Subject: Lake Powell Hydroelectric Project No. 12966
Response to Comments on the Draft Study Reports and Initial Study Report Meeting

Lake Powell Pipeline Project Responses to Participant Comments on Draft Study Reports

Chart 1

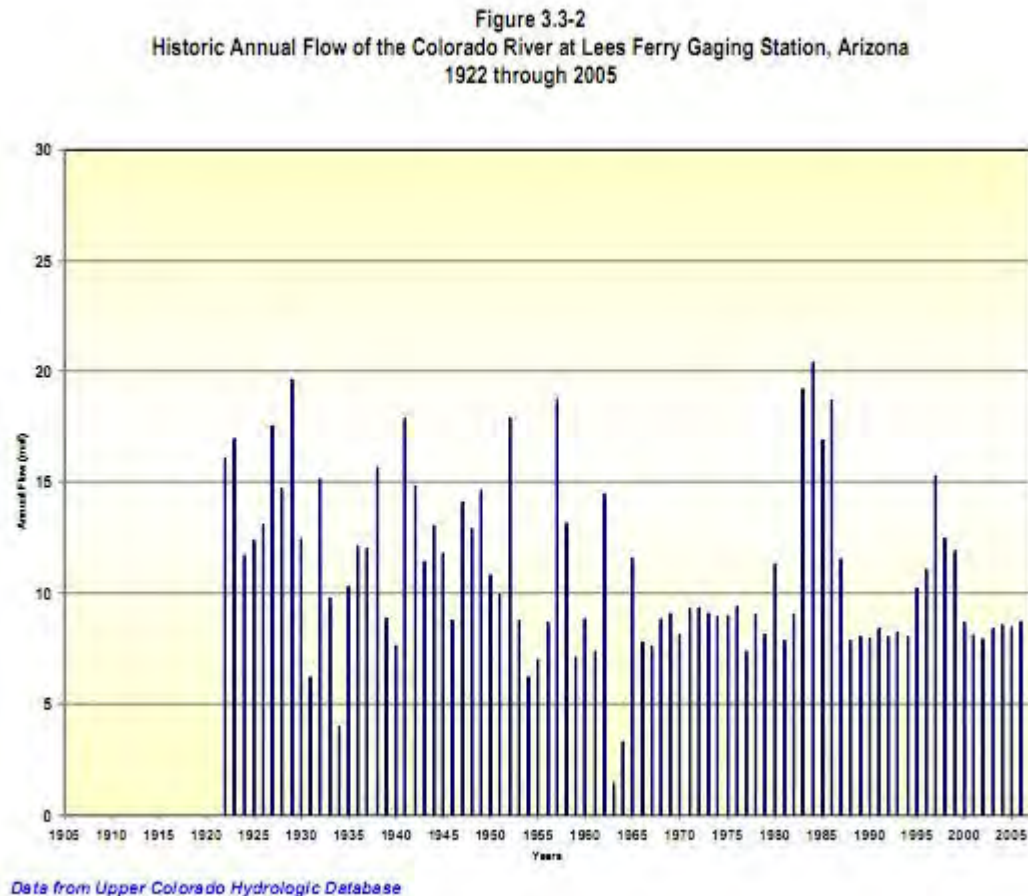
We disagree with continuing to use of 15 (maf) as the average flow to assess environmental impact of the LPP. The study report should consider a range of flows at the Lees Ferry gauging station. Chart 1 shows the historic annual flow 15 (maf) as an average is an optimistic assumption for future water availability.

Chart 11

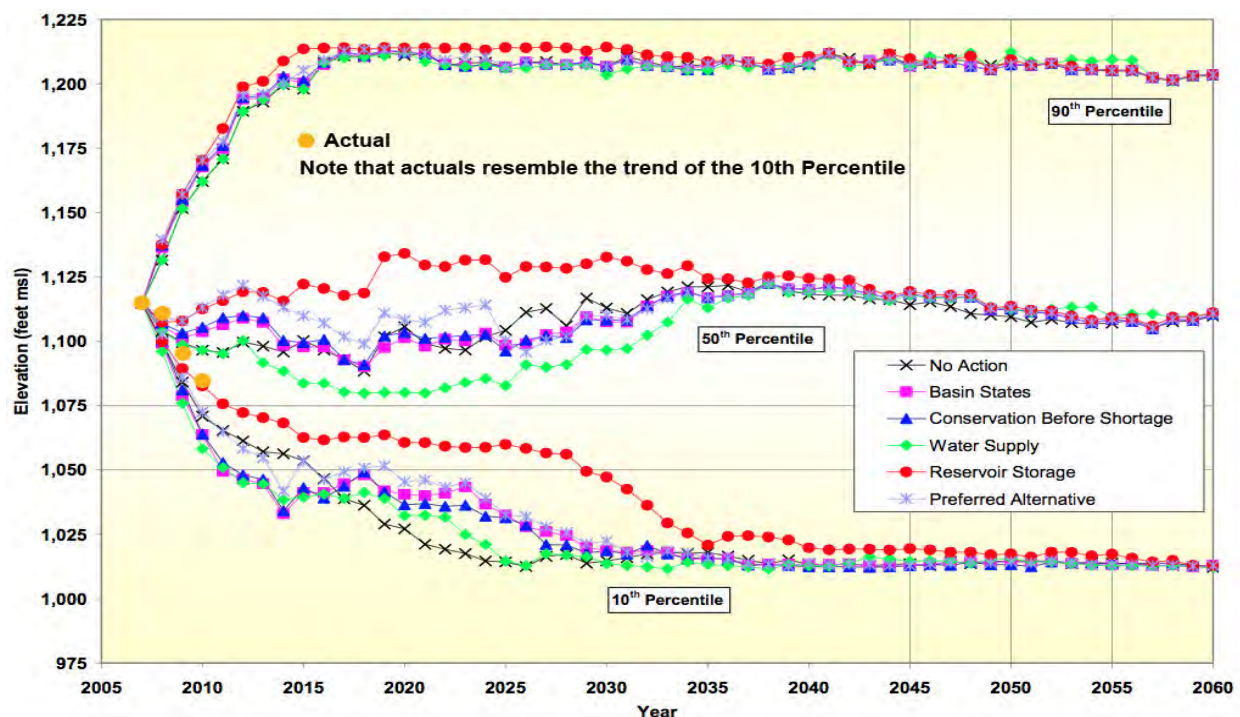
The model used for the Interim Guidelines predicted most probable 50th percentile and did not predict the fall of Lake Mead. The 10% percentile (minimum probable) correctly predicted the fall of Lake Mead. Using the 10th percentile as most probable is proving to be a better predictor of future conditions and could be used for a range of conditions to assess future environmental impacts on elevation and storage in Lake Powell.

Figure 2. Average annual total system hydrologic inflows for the Colorado River Basin through 2060

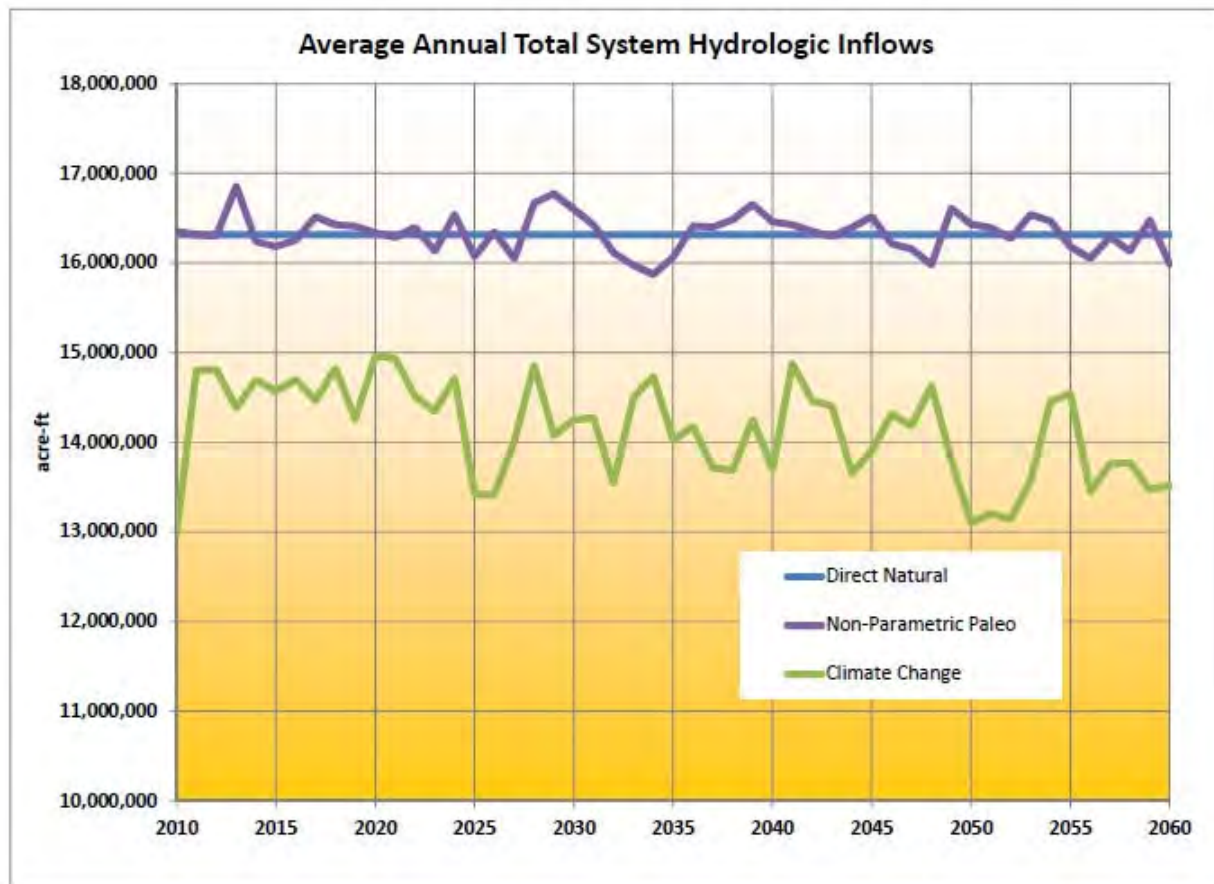
However, the study report fails to address an important corollary question: to what extent would limits on water supply in Lake Powell impact the physical ability of the Lake Powell Pipeline to deliver water? Chapter 4 of the same study report 19 assesses water availability in Lake Powell under two hydrologic scenarios, a) "direct natural" (projecting the 19062006 hydrologic record into

the future), and b) “nonparametric, paleoconditioned inflows” (projecting longterm past records of inflows, generated through study of tree ring records, into the future). Significantly, neither of these hydrologic scenarios is informed by climate change projections. Moreover, this analysis fails to address the finding reported earlier in the chapter that climate change impacts may cause Lake Powell to go dry. Figure 2, below, compares total basin inflows under three hydrologic inflow scenarios developed by Reclamation (direct natural, nonparametric paleoconditioned, and climate change) and demonstrates that the climate change flow scenario is considerably drier than either the direct natural or nonparametric paleoconditioned flow scenarios.

Figure 3. Projections under climate change scenario of the probability of Lake Powell falling below 3375 feet through 2060.

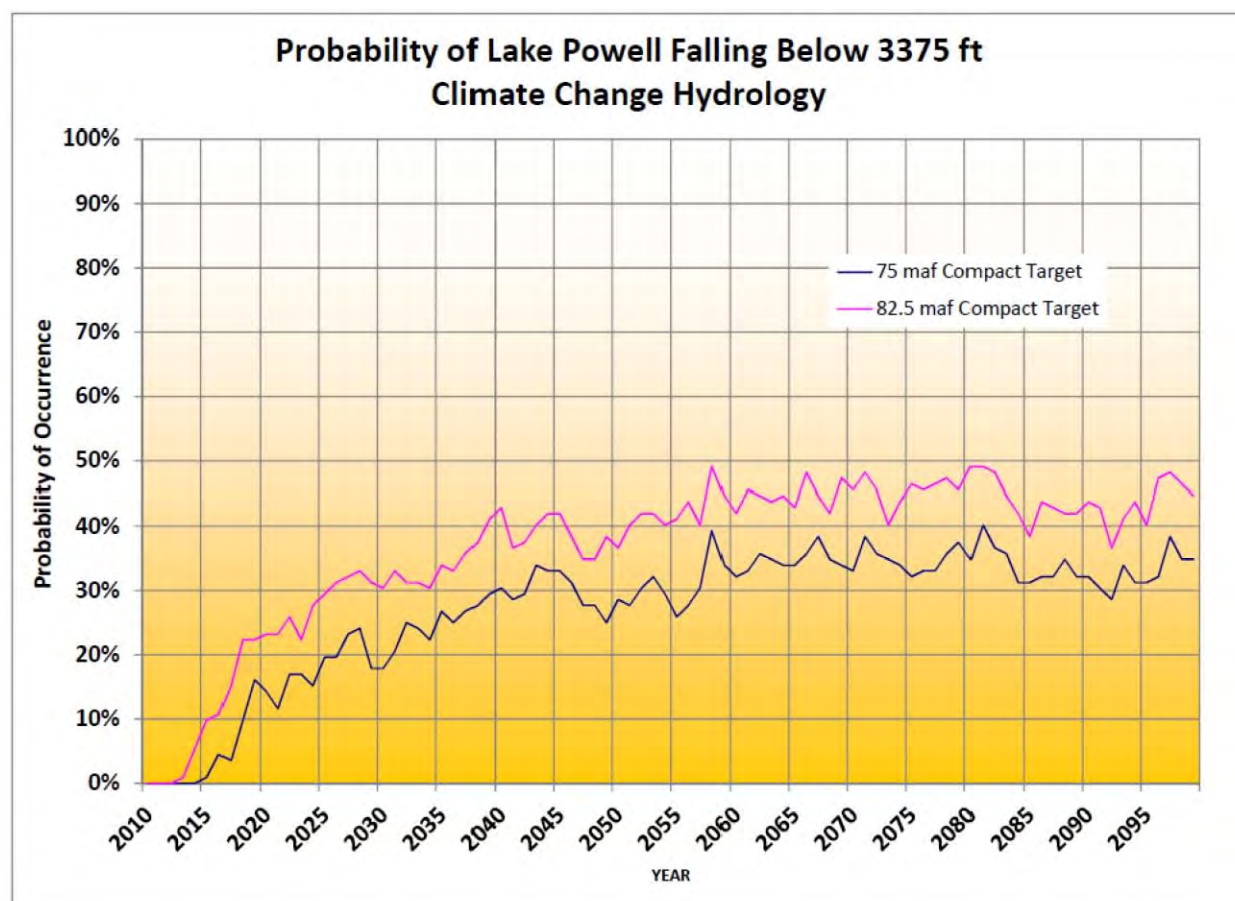
We prepared an independent CRSS analysis of Lake Powell water supply that uses a climate change inflow scenario similar to that published in Reclamation's SECURE report, and assumes Compact deliveries at the 75 million acrefoot level. This analysis projects a 27% probability that the water surface elevation in Lake Powell would be below 3375 feet msl (the stated intake level for the proposed project) in any given year between 2010 and 2099 (see figures 3 and 4). If the compact delivery obligation is assumed to be 82.5 million acrefeet the probability of Lake Powell falling below 3375 feet msl increases to as much as 37%. We urge the Commission to require the project proponent, working with Reclamation, to replicate these analyses themselves. We urge the Commission to find that study report 19 has not been properly conducted because the analysis does not consider hydrologic conditions projected for the time period during which the project is proposed to be operational, and because the CRSS analysis used is flawed in that it does not demonstrate implementation of the Compact.

Chart 12

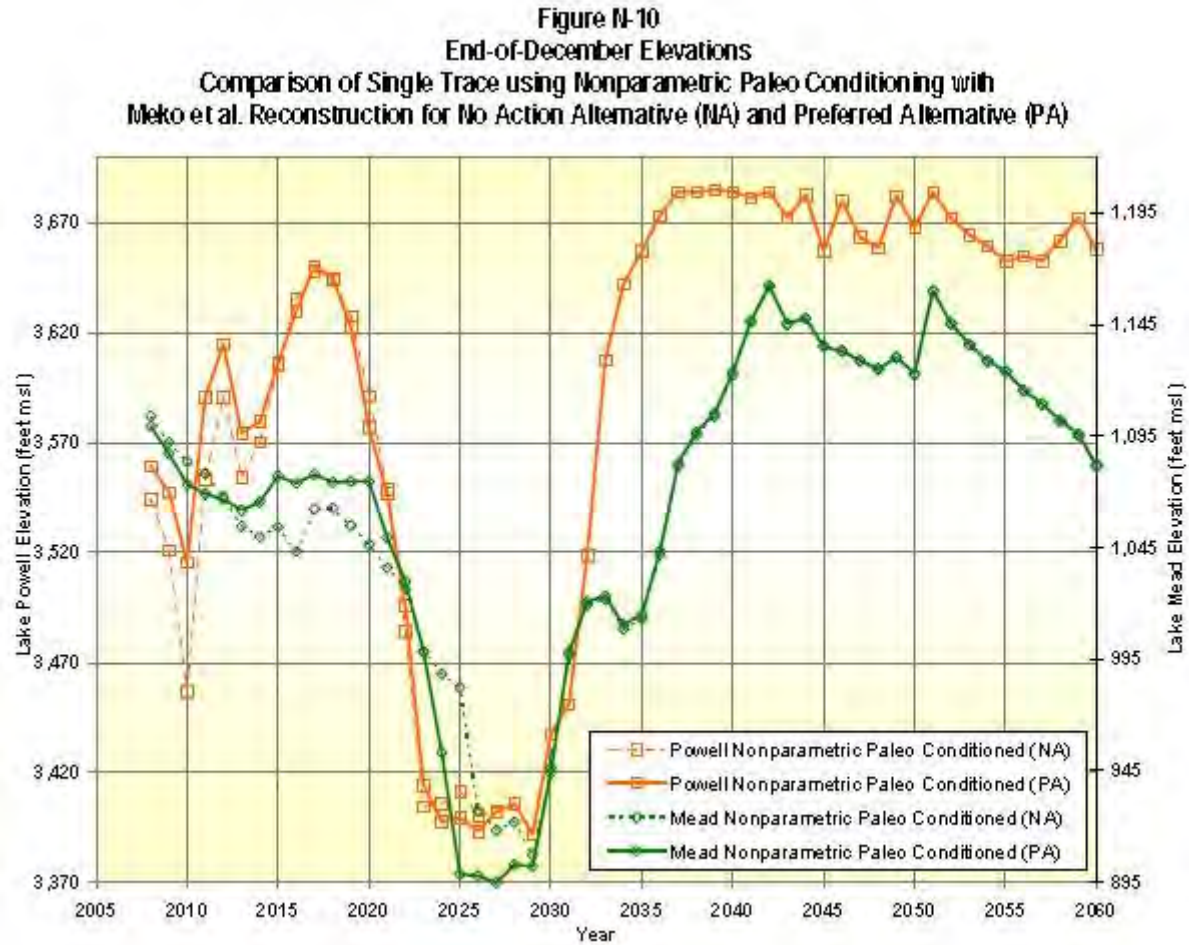
The Applicant states in the report: When comparing the four models of hydrologic inflows to the likelihood of being below the minimum power pool elevation (3490 feet msl) for Lake Powell, the DNF model run shows nearly no chance of falling below, where the Nonparametric Paleo-Conditioned) (NPC) Inflow model (NPC) indicates the highest likelihood of occurrence by 26 percent after 2055. However, in Chart 12 below, the NPC predicts drought at 2025 in the Interim Guidelines. The report also continues to misinterpret the science to state the highest probability of shortage for lower basin is after 2055. However, in reviewing chart 13 below, drought and shortage are predicted for the Lower Basin within 50 years term of the license and risk of shortage is why the Interim Guidelines were developed for the Lower Basin States. In addition, in the Interim Guidelines EIS, under Environmental Consequences, page 4-101, figure 4.4-2 shows Lower basin shortage occurring in the 50th percentile, most probable, occurring by 2025. Scientific studies and evidence pointing to the possible risks of shortage to the LPP and Lower Basin cannot be ignored in these study reports.

This chart shows drought occurring before 2055 as predicted in the report

Chart 13

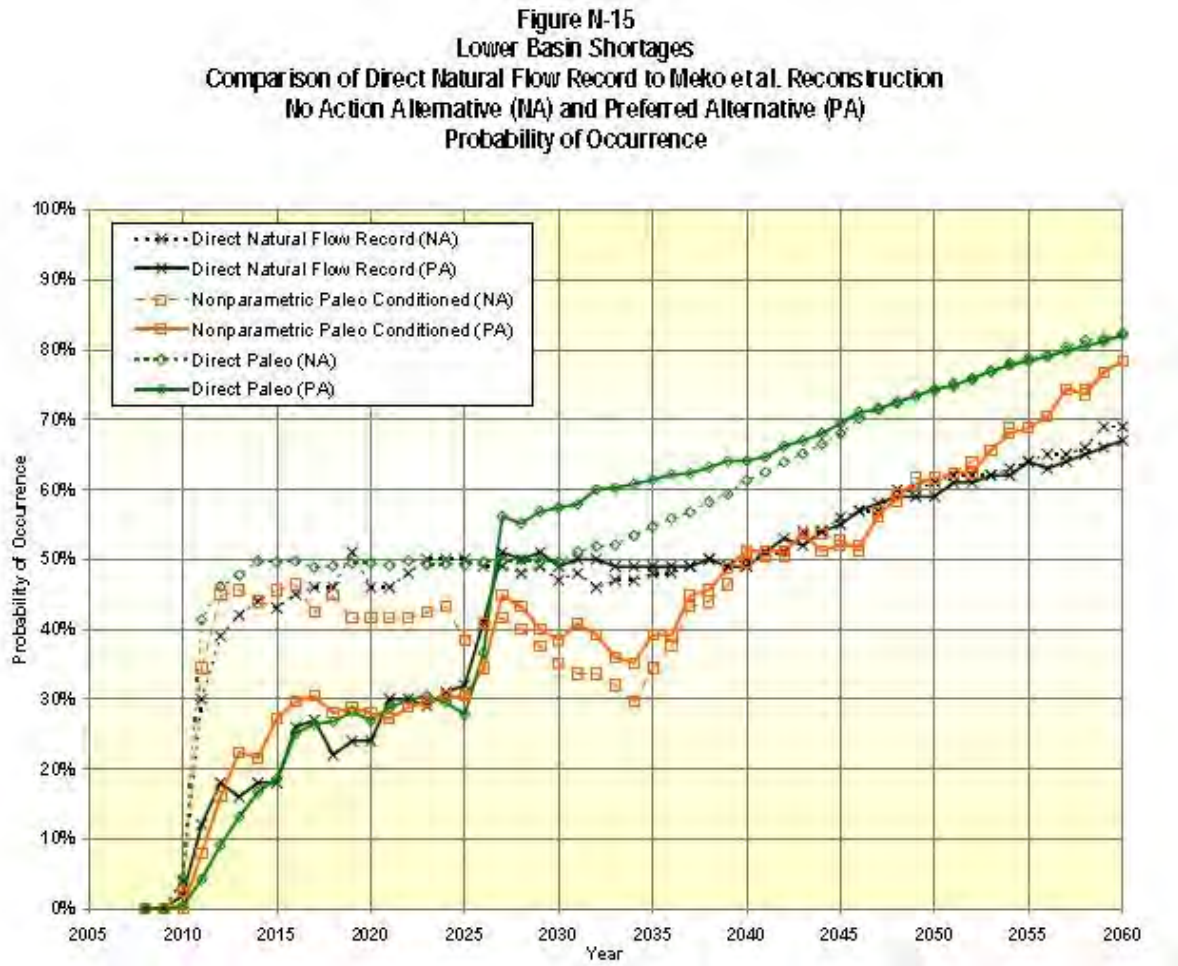
Interim Guidelines EIS 2007 Appendix N page N-23 Figure N-15, shows high probability of shortages in Lower Basin

The comment includes Figure N-15 and incorrectly interprets it as follows, stating: “...drought and shortage are predicted for the Lower Basin within 50 years term of the license and risk of shortage is why the Interim Guidelines were developed for the Lower Basin States.” This conclusion is drawn on Appendix N, which is introduced as “the analysis of the sensitivity of the hydrologic resources to alternative hydrologic inflow scenarios” as stated in Section N.1 Introduction, Appendix N. The draft study report text in Section 2.3 states: “These differences are noted in the sensitivity analysis, and the DNF hydrology was used for the modeling of alternatives in the final EIS.” The UDWR concludes that the review of the Interim Guidelines FEIS Hydrology as presented in the draft study report is correctly interpreted.

Figure 66. Change in percentage mean annual runoff distributed over the West.

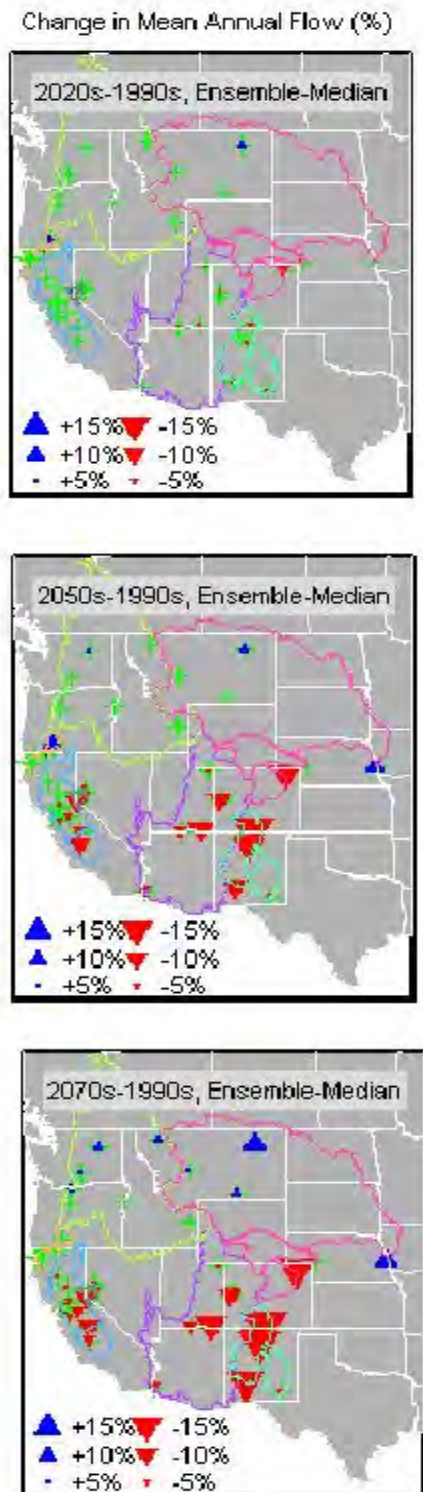
The chart below show predictions of lower flows for the Colorado River and should be included in this study report. The Applicant must include effects on resources and water availability over the term of license from 2020-2070 that include the estimated flow reductions of the Colorado River predicted in Reclamation’s new report. The Applicant must disclose these possible impacts of reduced flow in the study report so the Commission can make informed decisions on an adequate impact analysis and make a look before you leap approach.

The UDWR literature review summarized in the draft study report complies with the approved study plan. Figure 66 from the 2011 Reclamation Secure Water Act section 9503 (c) Report, incorporated into the comment, is accompanied by the following text: “Changes in surface water runoff are more complex than projections of snowpack. Analyses of historical runoff suggest that any trends in annual or seasonal runoff are weak. Hydrologic analyses based on future climate projections suggest that geographic trends may emerge (figures 66 and 67). The Southwestern United States to the Southern Rockies may experience gradual runoff declines during the 21st century and the Northwest to north-central United States may experience little change through the mid-21st century with increases projected for the late 21st century (figure 66).” The introduction to the West-wide Summary of Hydroclimate Changes section (which includes figure 66) of the 2011 Reclamation Secure Water Act Section 9503 (c) Report states: “It is noted that these summary statements reflect regionally averaged changes and that projected changes have geographic variation; they vary through time; and the progression of change varies among climate projection ensembles...” The comment misrepresents the 2011 Reclamation Secure Water Act Section 9503 (c) Report regarding snow water equivalent: “Snow water equivalent will be down by 50% in 2020, down by 60% by 2050, and down by 66% in 2070.” Section 2.4.1 of the report summarizes climate and hydrologic changes in Table 1, which reflect a subbasin-average view and measured relative to 1990s baseline conditions. The summary of simulated changes in decade-mean hydroclimate for the Colorado River at Lees Ferry subbasin in Table 1 shows the mean April 1st snow water equivalent (percent) as -50.0 in the 2020s, -60.6 in the 2050s, and -66.9 in the 2070s. The comment incorrectly assumes a 50 year license period, which has not yet been determined by FERC.

Figure 1. Residential building permits in Washington County.

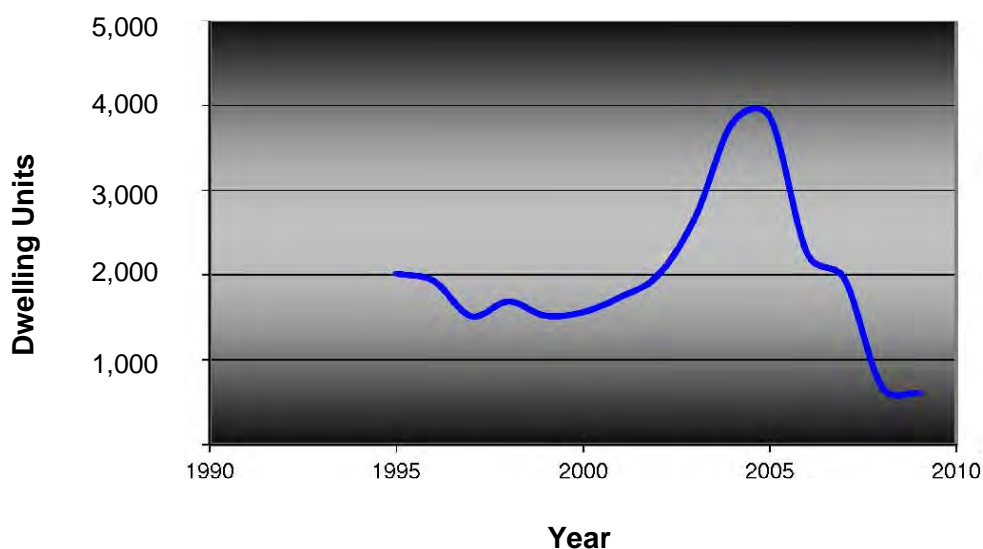
Population projections are heavily dependent on the initial estimate of population and the rate of population growth, where errors in the first few years are compounded greatly over time. The current economic slowdown in Utah will play a significant role in reducing estimated future water demands by decreasing population growth rates over the next few years. Importantly, foreclosures in Washington County are the second highest in the state (1 in every 168 homes) and building permits have decreased precipitously since 2005 (Figure 1), strongly indicating that future growth rates should be much lower than those projected in the WNA. Future demands will not be as high as currently projected, even if growth continues at the expected rate ten or more years from now, because growth is held up at this time.

Figure 2. Marginal Price Curve of Water Rate Structures for Southwest Communities.

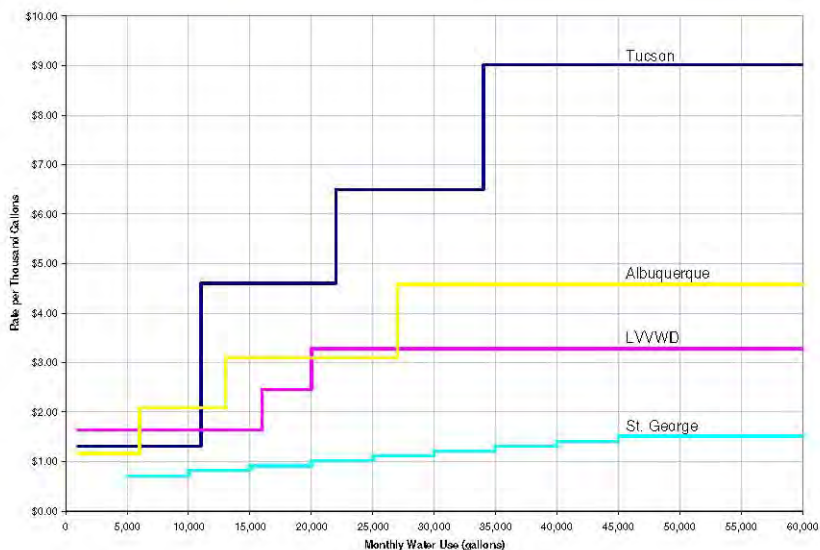
16. As one local example, St. George's increasing block rate structure does not provide an adequate conservation price signal (Figure 2). Because the price differential between blocks in St. George's water rate structure is small and the fixed price is high, customers receive no financial signal when they consume excessive amounts of water. This is in direct contrast to customers in Tucson or Albuquerque which see the average price of water increase dramatically as their water use increases.
